METROPOLITAN GOVERNMENT OF NASHVILLE AND DAVIDSON COUNTY

STAFF RECOMMENDATION
913 Fatherland Street
December 18, 2013

Application: New construction-infill and outbuilding
District: Edgefield Historic Preservation Zoning Overlay
Council District: 06
Map and Parcel Number: 08216018200
Applicant: Sandi Adams, Rigid Development
Project Lead: Sean Alexander, sean.alexander@nashville.gov

Description of Project: The applicant is proposing to construct a new two-story house and garage on a vacant lot.

PLOT PLAN
 FOR
 LOT 91
 BARROW'S ADDITION OF EAST NASHVILLE
 PLAT BOOK 1, PAGE 93, R.O.D.C., TN.
 6TH COUNCIL DISTRICT
 NASHVILLE-DAVIDSON COUNTY-TENNESSEE
 SCALE: 1"=30' DATE: 10-9-14:REVISED 12-3-13
 HFR PROJECT NO. 2013200.52

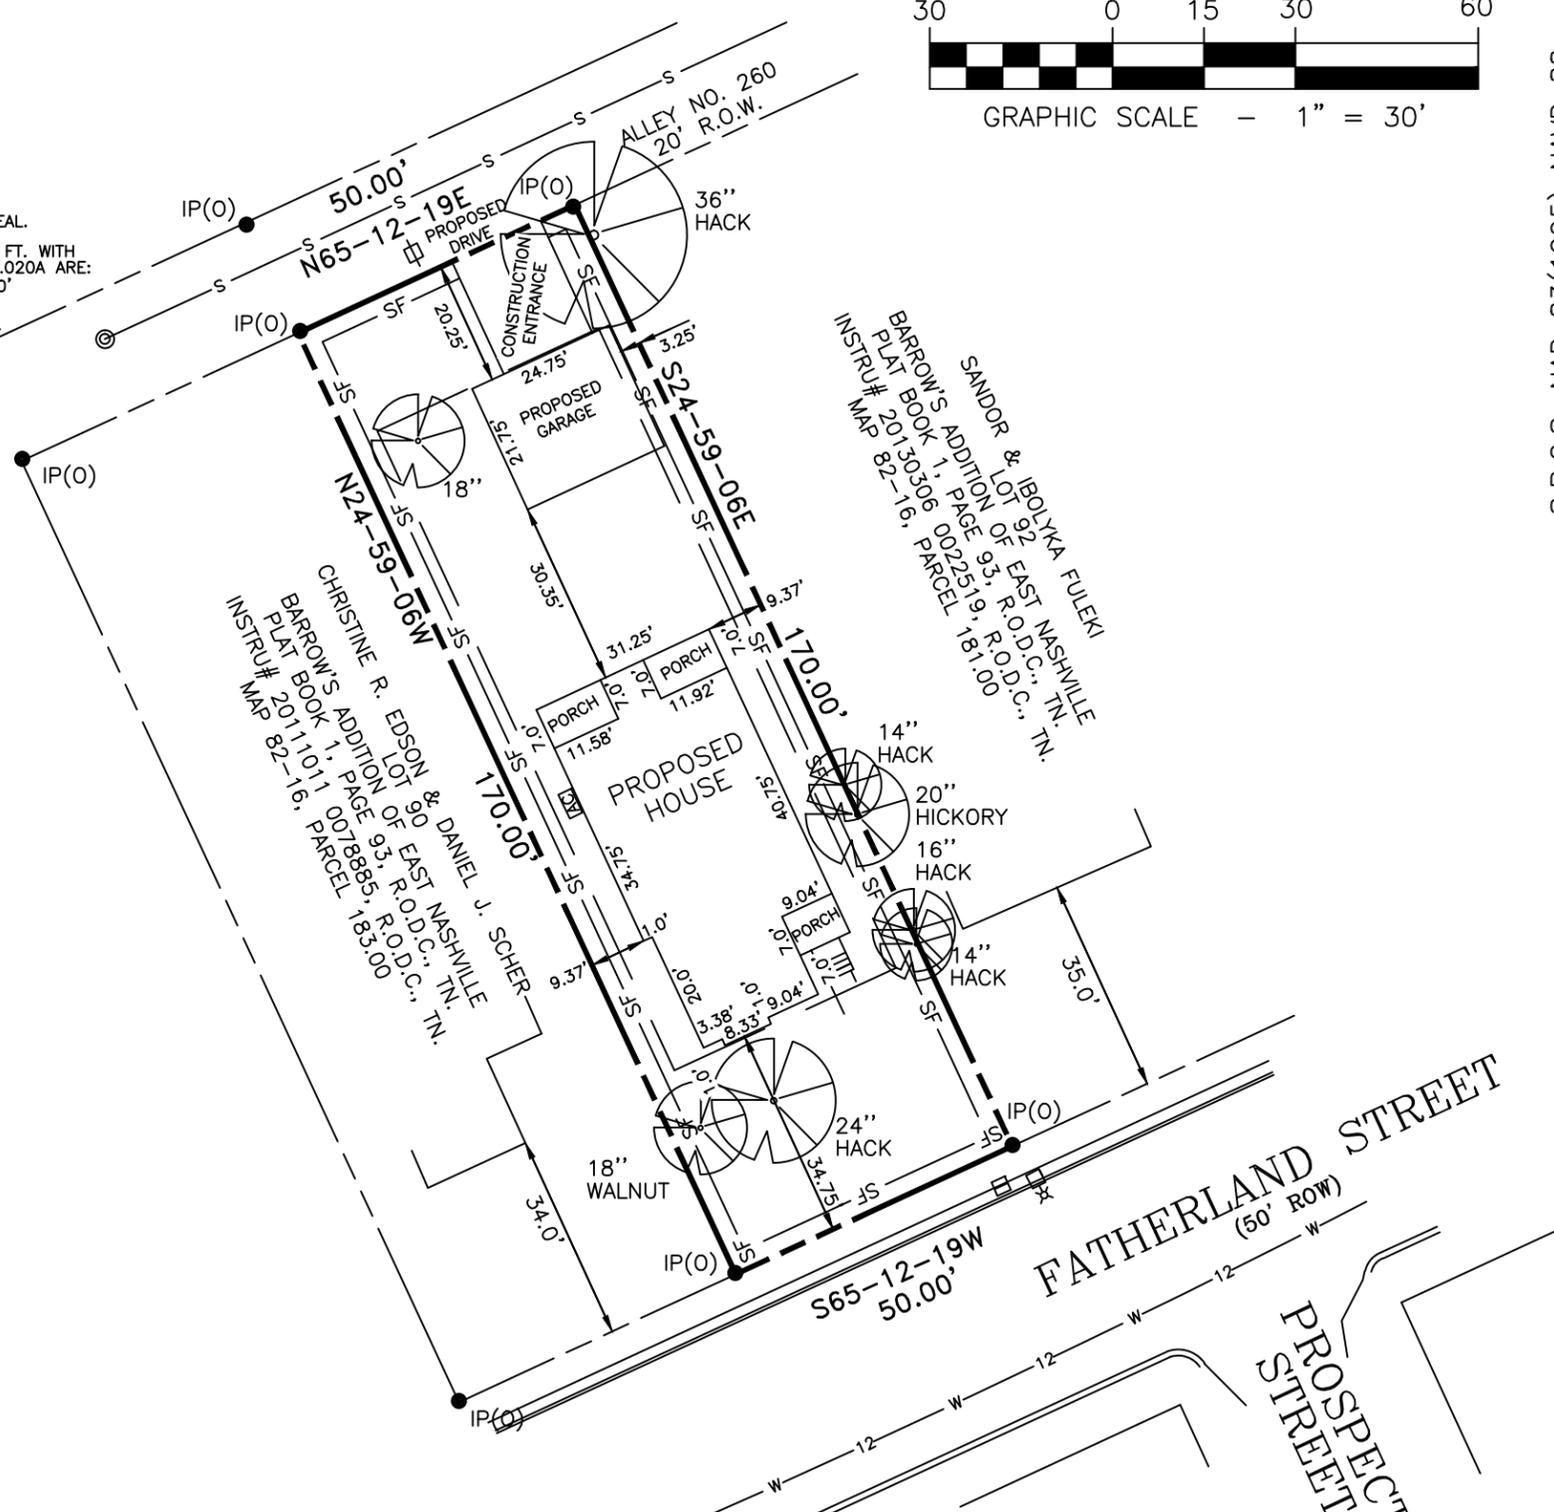
The house will be aligned perpendicularly to the street, matching the orientation of nearby historic houses. A walkway from the porch to the public sidewalk is needed to engage the street, as is typical of other houses in the district. With the addition of a walkway, Staff finds that the proposal will meet guideline III.B.2.e.

The proposal also includes a garage to be located at the rear of the property, accessed from the rear alley. The garage will be set three feet in from the right property line and twenty-feet (20') from the rear. This location is compatible with the locations of historic outbuildings and meets guideline III.B.2.h.2.

LEFT SIDE ELEVATION

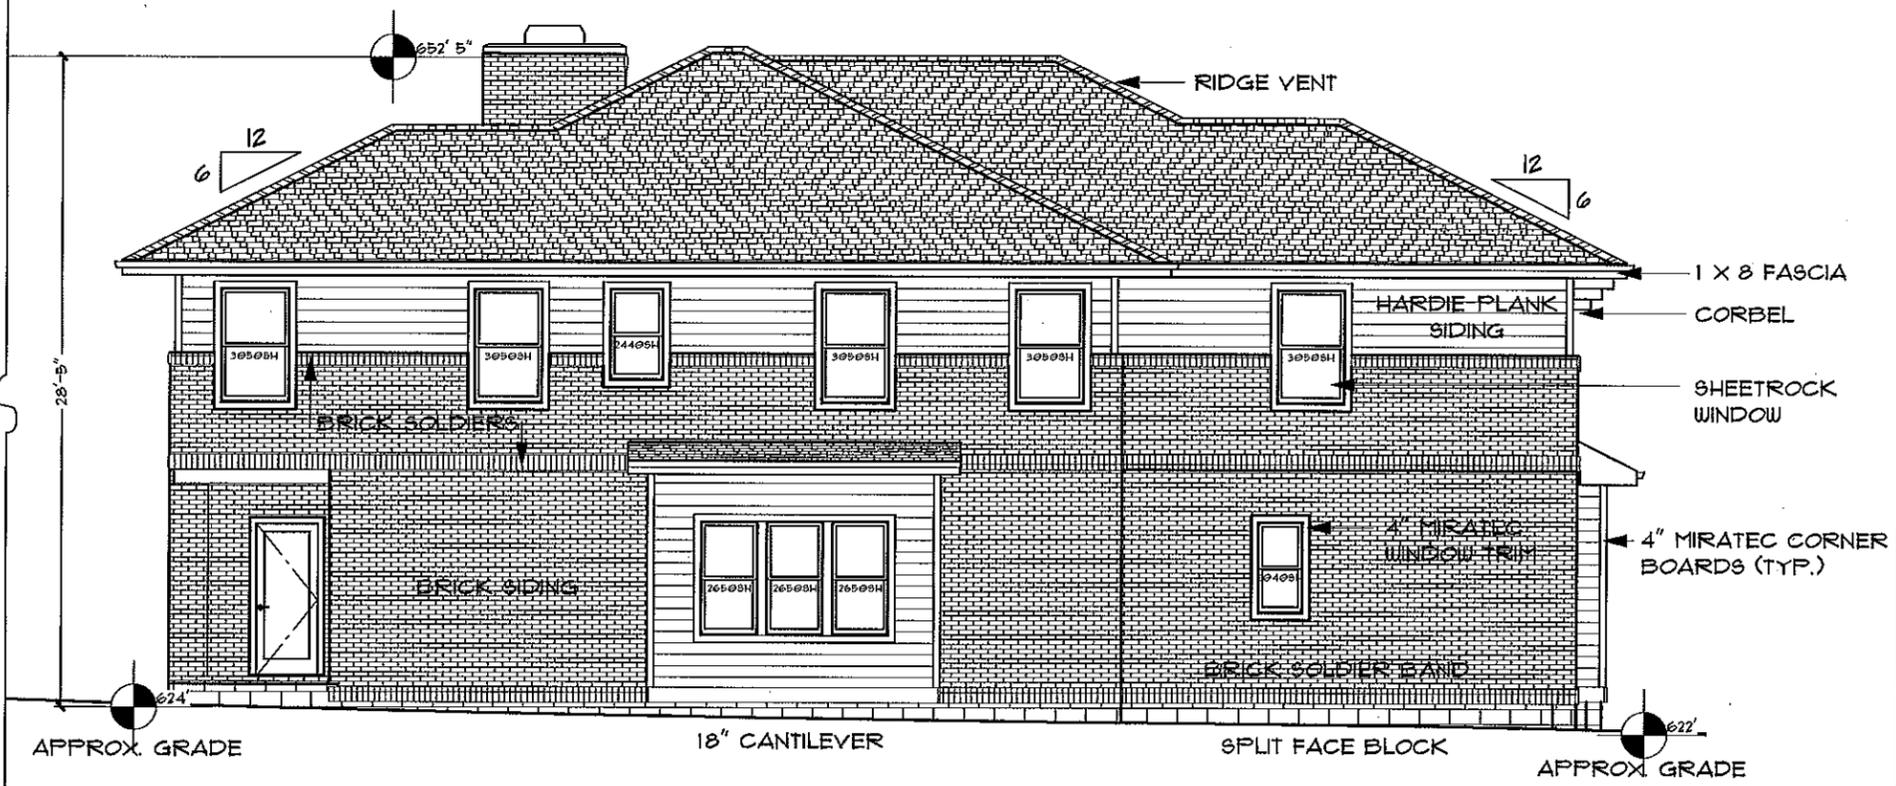
Generally, the windows of the first story are taller than those on the upperstory, as is typical of historic houses, and there are not large expanses of wallspace without any opening or articulation. In the left side, however, there is single window on a section of the wall that is disproportionate to the wall around and the window above. Staff finds that with this window enlarged to a more appropriate size, the application will meet guideline III.B.2.f.

- The elevations be revised to reflect the lot grade accurately;
- A walkway be added from the porch to the sidewalk;
- The windows on the left elevation be a more appropriate proportion;
- Brick color and texture, and the materials of windows and doors be approved by Staff;
- Permanent landscape features such as pavings, fences and walls, exterior lighting, and any other appurtenances be approved by Staff.
